From: Tim Walsh - Novo Group  
Sent: Wednesday, April 19, 2023 2:55 PM  
To: Cottam, Rachel <Rachel.Cottam@ccc.govt.nz>  
Subject: RE: RMA/2022/3611 - Request for further information 320A Cumnor Terrace

To: Tim Walsh - Novo Group <[tim@novogroup.co.nz](mailto:tim@novogroup.co.nz)>  
Cc: Lowe, Paul <[Paul.Lowe@ccc.govt.nz](mailto:Paul.Lowe@ccc.govt.nz)>; Higgins, John <[John.Higgins@ccc.govt.nz](mailto:John.Higgins@ccc.govt.nz)>; Weston, Tracey <[Tracey.Weston@ccc.govt.nz](mailto:Tracey.Weston@ccc.govt.nz)>; Ward, Sean <[Sean.Ward@ccc.govt.nz](mailto:Sean.Ward@ccc.govt.nz)>; Jorgensen, Craig <[Craig.Jorgensen@ccc.govt.nz](mailto:Craig.Jorgensen@ccc.govt.nz)>; Ben Owen <[ben@peeblesgroup.co.nz](mailto:ben@peeblesgroup.co.nz)>; [richard@peeblesgroup.co.nz](mailto:richard@peeblesgroup.co.nz); Rob Howe <[rob.howe@woods.co.nz](mailto:rob.howe@woods.co.nz)>; Chris Greenshields <[chris@dcmurban.com](mailto:chris@dcmurban.com)>  
Subject: RMA/2022/3611 - Request for further information 320A Cumnor Terrace

**PORTLINK INDUSTRIAL PARK**  
**STAGE 6-8**  
 TOPO SURVEY OF FILLED LEVELS  
 ALONG ORIGINAL HAUL ROAD

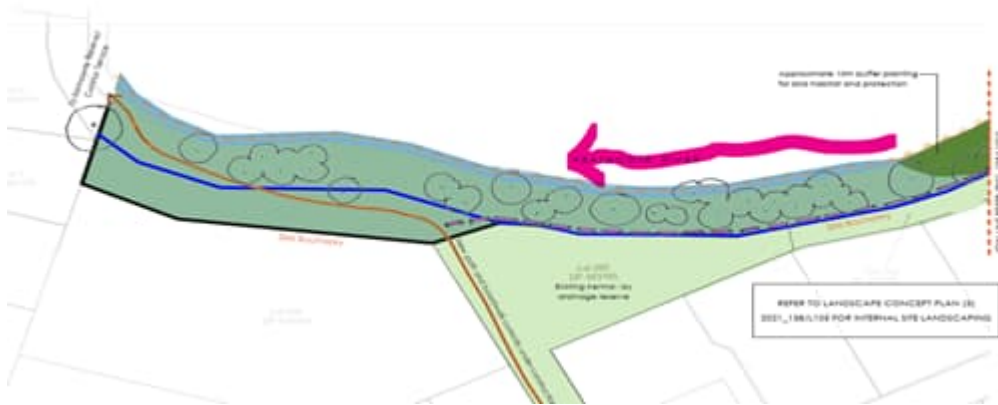
The ecologists are relatively happy with the proposed landscaping plan subject to the comments below. There may be some detailed conditions in terms of landscaping. The bird habitat needs to be extended to the H in the Heathcote river as shown above however the lizard habitat can remain as proposed on the plans. In terms of the haulage route, the area will be sheet/shaped to flow gently to the river (sloped 2% to the top of the bank) and will require the illegal channel to be filled as part of these works.

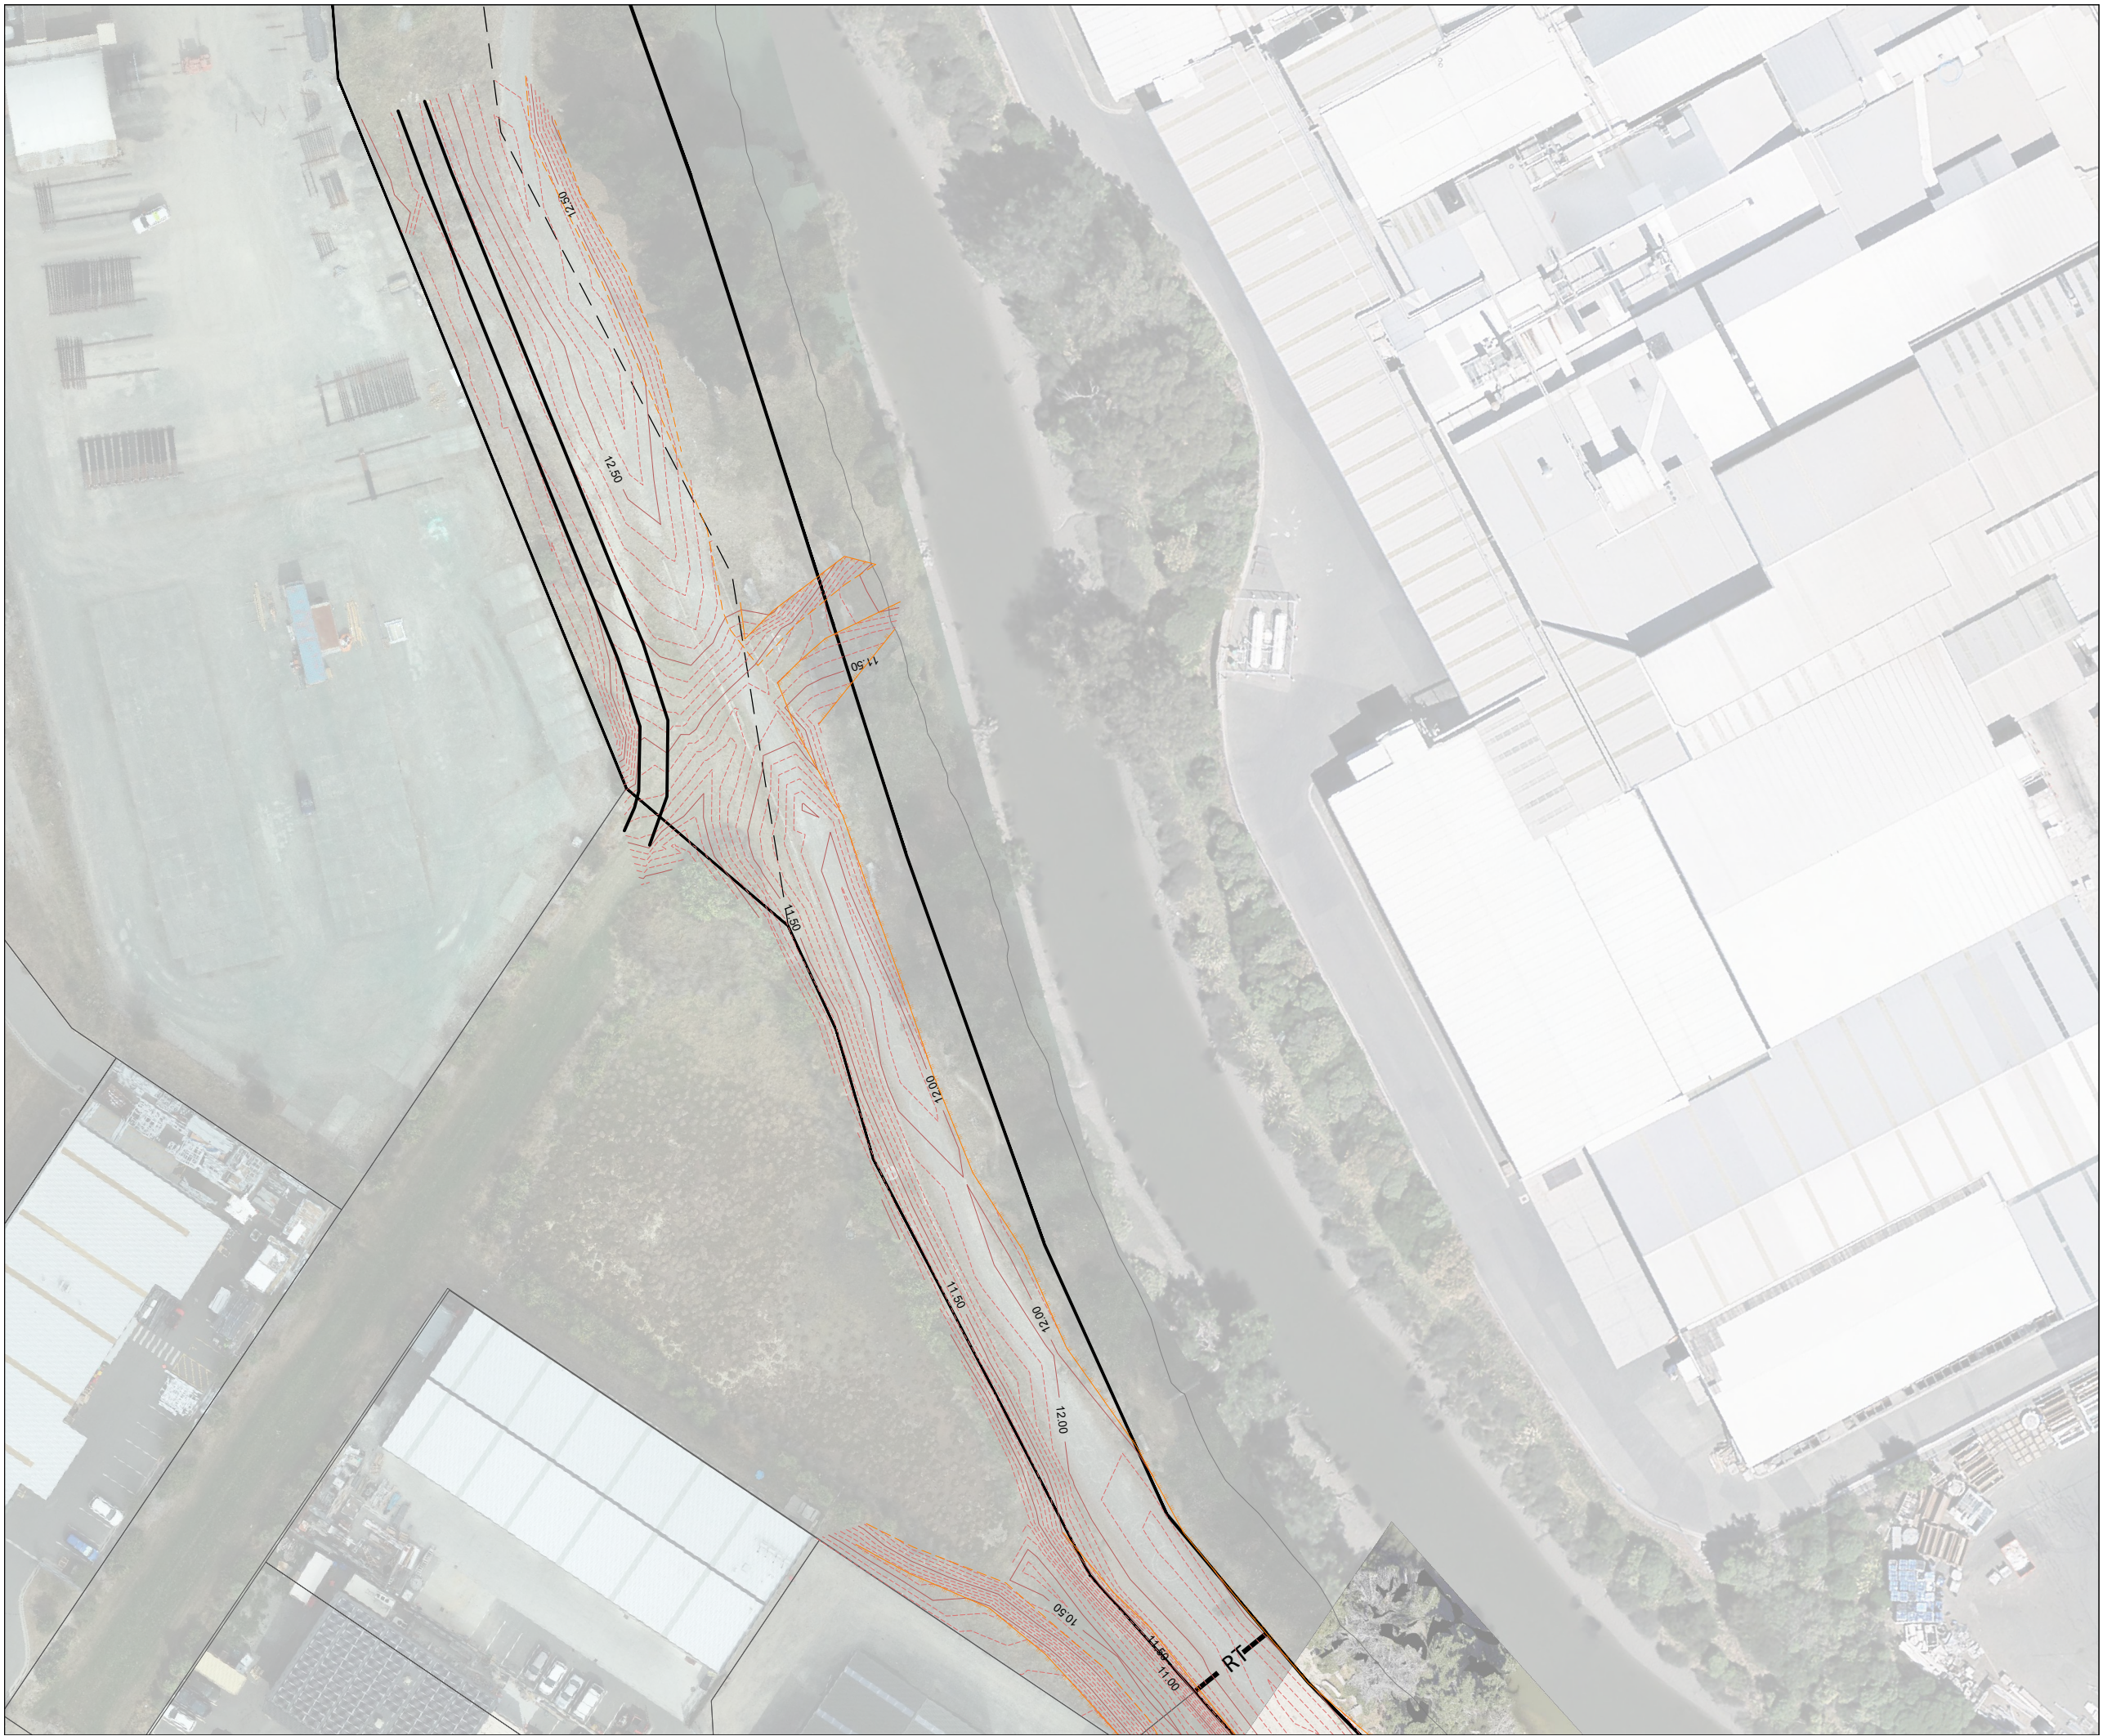
3. In terms of the arborist report provided, it is unclear where the location of the trees are. Please can this be identified on a hand annotated aerial map. Once I have this, I can sent this through to the arborist for comment.
4. We require a finished levels plan for Lot 305. The channel you have mentioned in your RFI response at 75/81 Kennaway Road is illegal and all industrial lots should be draining directly to Kennaway Road. We need to obtain confirmation that Lot 305 is not draining into 75/85 Kennaway Road to determine the next compliance steps.
5. We need a further as-built of the remainder of the haulage route fill highlighted in pink below. The current as built only shows levels up to the first flush wetland and not the start of the haulage route. Please ensure the landscaping plan also starts at the start of the haulage route entrance.

In response to item 5, please find attached the as-built plans for the haul road. As per the application, some minor earthworks are required in the area shown in this plan "to bury the haul road, to provide a bed of topsoil for planting, and regrade towards the river".
